Appendix A. HAZOP Recommendations

DRG No. **PKGT-LOG-ORF-PRO-PAIA-0009** Rev **B**

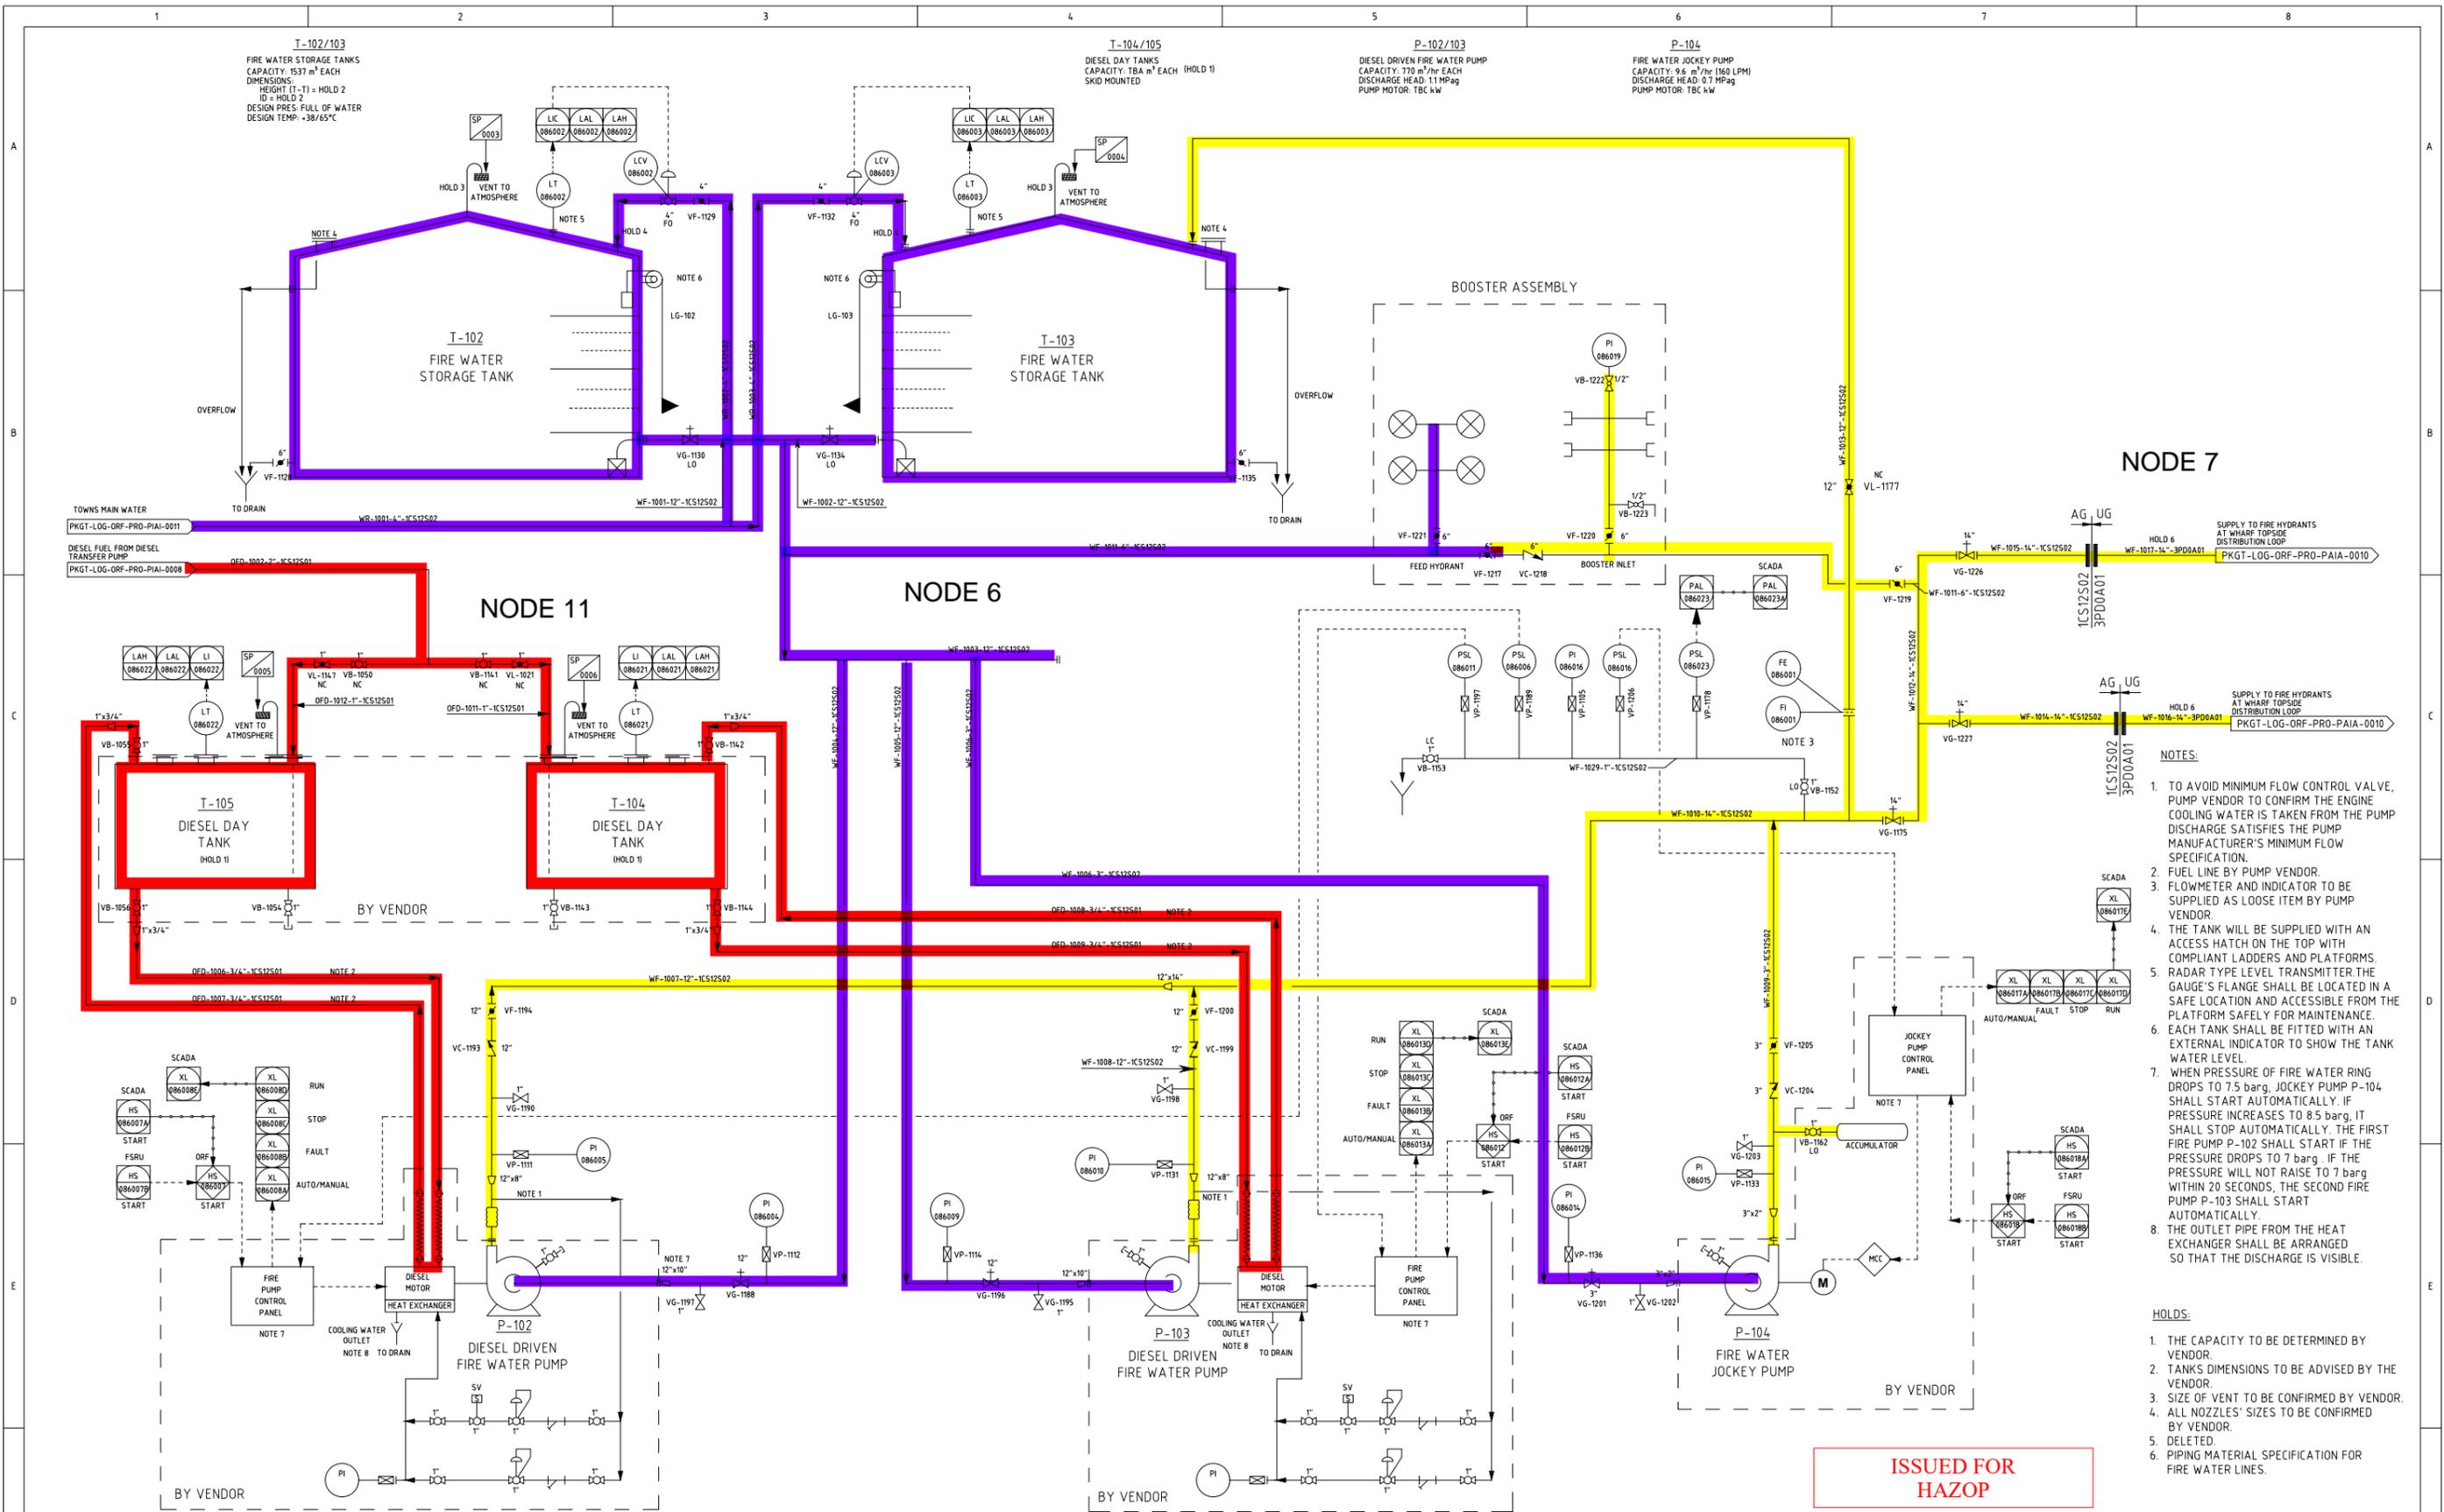
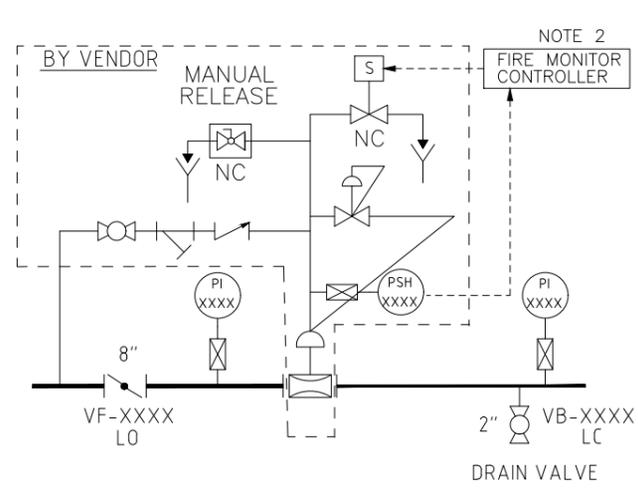
| Node | Recommendations | Place Used | Status | Noggin Status |
|--|--|----------------|--|---------------|
| 6. Firewater System (Upstream of Pump) | 4. Obtain written confirmation from water authority for minimum pressure and flowrate expected for the next 15 years. | Causes: 6.2.1 | No change. | Closed |
| 6. Firewater System (Upstream of Pump) | 5. Develop procedure for periods of time when less than 100% fire water capacity is available (e.g. due to 5 yearly tank inspection) | Causes: 6.2.1 | No change. | In progress |
| 6. Firewater System (Upstream of Pump) | 6. Confirm capacity of booster connection meets requirements of local fire authority. | Causes: 6.2.3 | No change. | In Progress |
| 6. Firewater System (Upstream of Pump) | 8. Indicate size of fire water tank overflow on P&ID. | Causes: 6.5.1 | No change. | Closed |
| 6. Firewater System (Upstream of Pump) | 9. Confirm tank vent and overflow sized for pump discharge scenario. | Causes: 6.8.1 | No change. | Closed |
| 6. Firewater System (Upstream of Pump) | 10. Confirm materials of construction for drain and overflow lines and indicate on P&ID. | Causes: 6.13.1 | No change. | Closed |
| 6. Firewater System (Upstream of Pump) | 11. Consider staggering level controller set-points to minimize interference potential. | Causes: 6.17.1 | No change. | In Progress |
| 6. Firewater System (Upstream of Pump) | 12. Confirm AS 1851 requirements regarding pump testing (frequency of flow testing, and need for return flow to both tanks). | Causes: 6.19.1 | No change. | Closed |
| 6. Firewater System (Upstream of Pump) | 13. Global: Confirm design includes grounding of metallic structures including fire water tanks. | Causes: 6.21.1 | No change. | Closed |

DRG No. **PKGT-LOG-ORF-PRO-PAIA-0010** Rev **B**

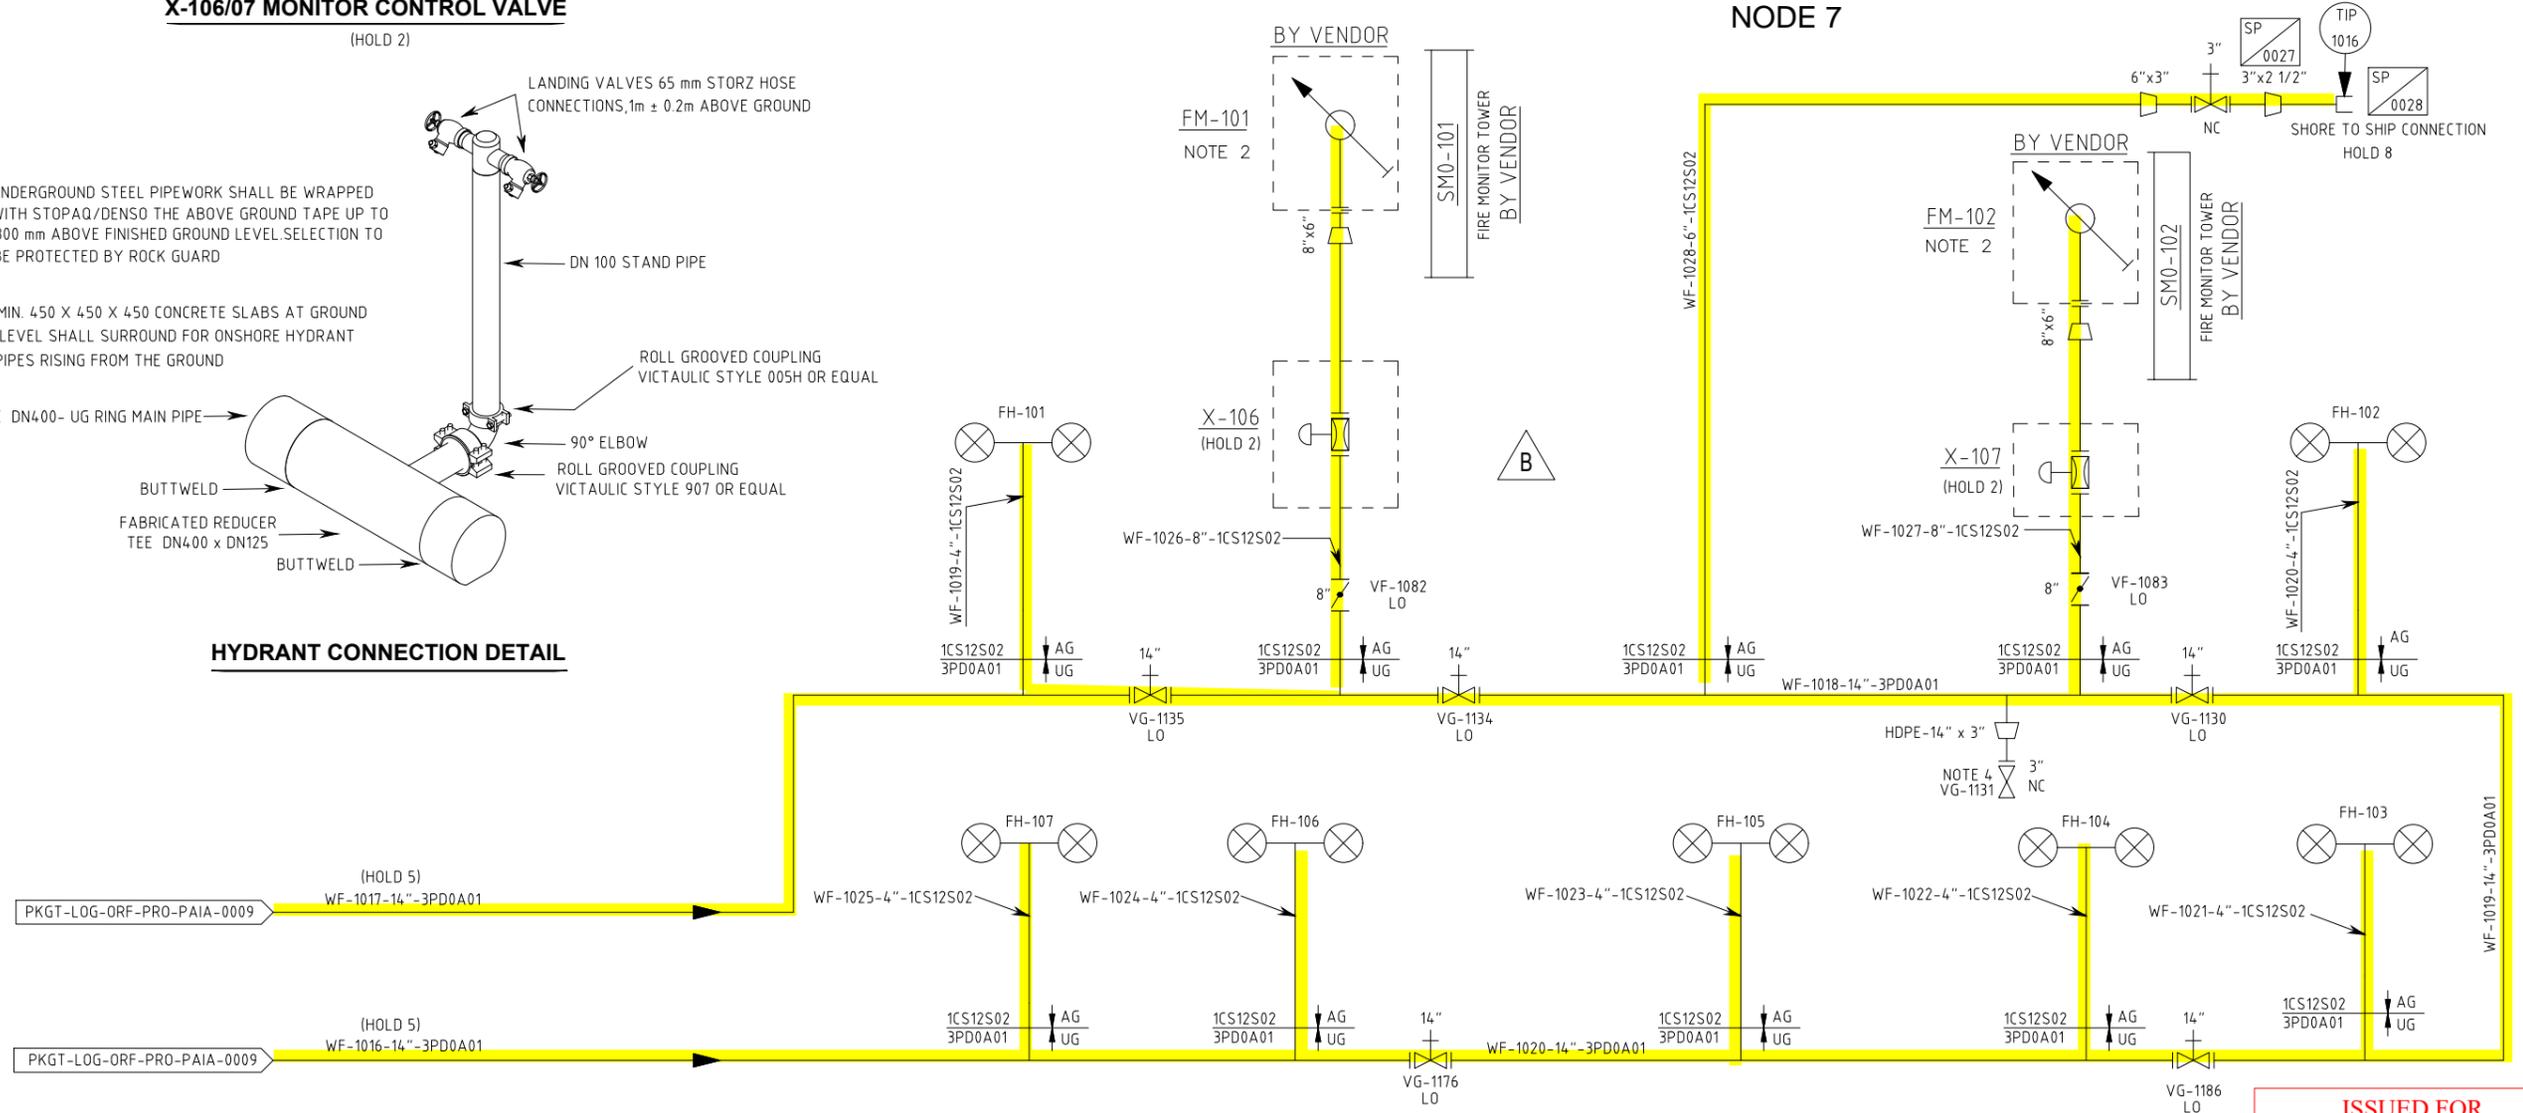
| Node | Recommendations | Place Used | Status | Noggin Status |
|--|--|----------------|--|---------------|
| 7. Firewater System (Downstream of Pump) | 14. Confirm fire water pumps are selected to allow for simultaneous operation. | Causes: 7.1.1 | No change. | Closed |
| 7. Firewater System (Downstream of Pump) | 15. Valve on fire water recycle line (VL-1177) to be locked closed. | Causes: 7.1.2 | No change. | Closed |
| 7. Firewater System (Downstream of Pump) | 16. Confirm output function of fire water pump overspeed trip. | Causes: 7.1.4 | No change. | Closed |
| 7. Firewater System (Downstream of Pump) | 17. Confirm with vendor inbuilt firewater pump protections, and acceptability of running pumps for extended period of time with no forward flow. | Causes: 7.3.1 | No change. | Closed |
| 7. Firewater System (Downstream of Pump) | 19. Consider sprinkler protection within fire water pump house. | Causes: 7.3.3 | No change. | In Progress |

| Node | Recommendations | Place Used | Status | Noggin Status |
|--|---|----------------|--|---------------|
| 7. Firewater System (Downstream of Pump) | 20. Confirm with Höegh that FSRU fire water system can cover MLA area. | Causes: 7.3.5 | No change. | Closed |
| 7. Firewater System (Downstream of Pump) | 21. Indicate VF-1217 to be LC on P&ID. | Causes: 7.4.2 | No change. | Closed |
| 7. Firewater System (Downstream of Pump) | 22. Confirm with Höegh that shore-to-ship connection is only to be made as required. | Causes: 7.4.3 | No change. | Closed |
| 7. Firewater System (Downstream of Pump) | 23. Consider non return valve in shore-to-ship line. | Causes: 7.4.3 | No change. | Closed |
| 7. Firewater System (Downstream of Pump) | 24. Confirm discharge pressure of FSRU fire water system | Causes: 7.7.2 | No change. | Closed |
| 7. Firewater System (Downstream of Pump) | 25. Ensure monitor deluge valve internals (seat) are epoxy coated rather than powder coated. | Causes: 7.7.3 | No change. | Closed |
| 7. Firewater System (Downstream of Pump) | 26. Confirm requirement for thermal relief protection on firewater system | Causes: 7.7.4 | No change. | Closed |
| 7. Firewater System (Downstream of Pump) | 31. Include note on P&ID for pressure relief holes on hydrant storz connection caps. | Causes: 7.7.4 | No change. | Closed |
| 7. Firewater System (Downstream of Pump) | 28. Confirm with vendor jockey pump integral overpressure protection. | Causes: 7.7.5 | No change. | In Progress |
| 7. Firewater System (Downstream of Pump) | 29. Provide remote alarm on start-up of diesel fire water pumps. | Causes: 7.8.1 | No change. | Completed |
